Program Bulletin

SB-10057642-8866

CUSTOMER SATISFACTION PROGRAM

SUBJECT: ECM Wire Harness Contact

3905243

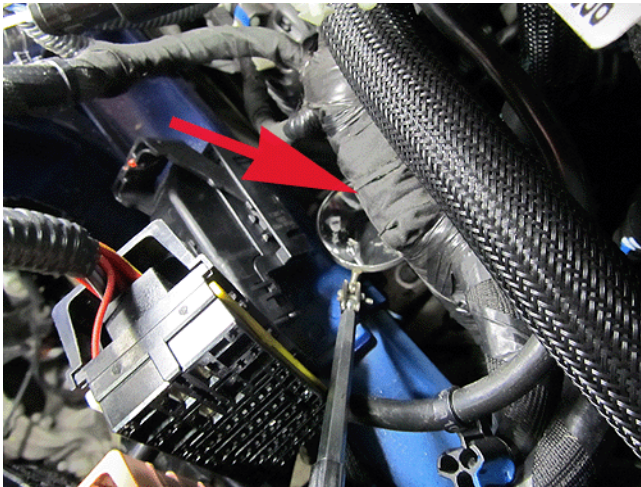
11. Prepare the new service bracket by wrapping three layers of Electrical/Anti Abrasive tape, such as Kent Automotive Part #1089482 or the equivalent, as shown.

3925939

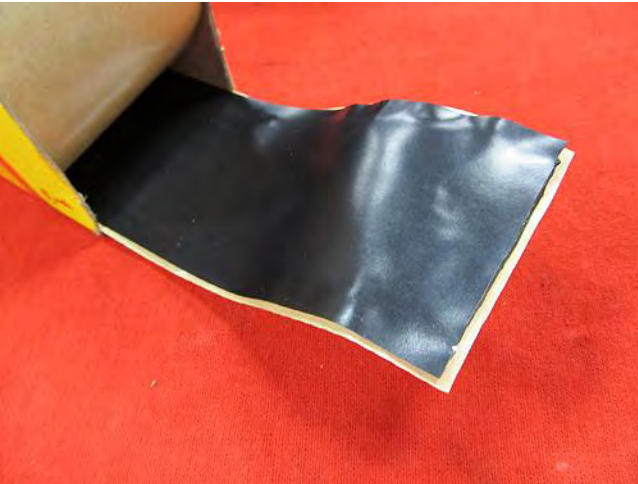
18. Locate the resistance spot welds on the inner right front frame rail.

3925935

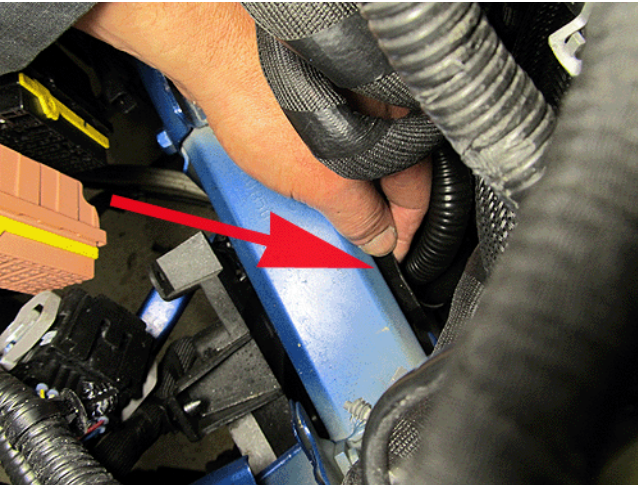
19. Prepare a 200mm (4.0 in.) section of 3-M Scotch Electrical Moisture Sealant Roll #06147, or the equivalent.

20. Install the material over the resistance spot welds as shown. This will prevent the rough welds from damaging the wiring harness that contacts the frame in that area.
21. Reinstall the Pre-fuse block.
22. Reinstall the ECM bracket.
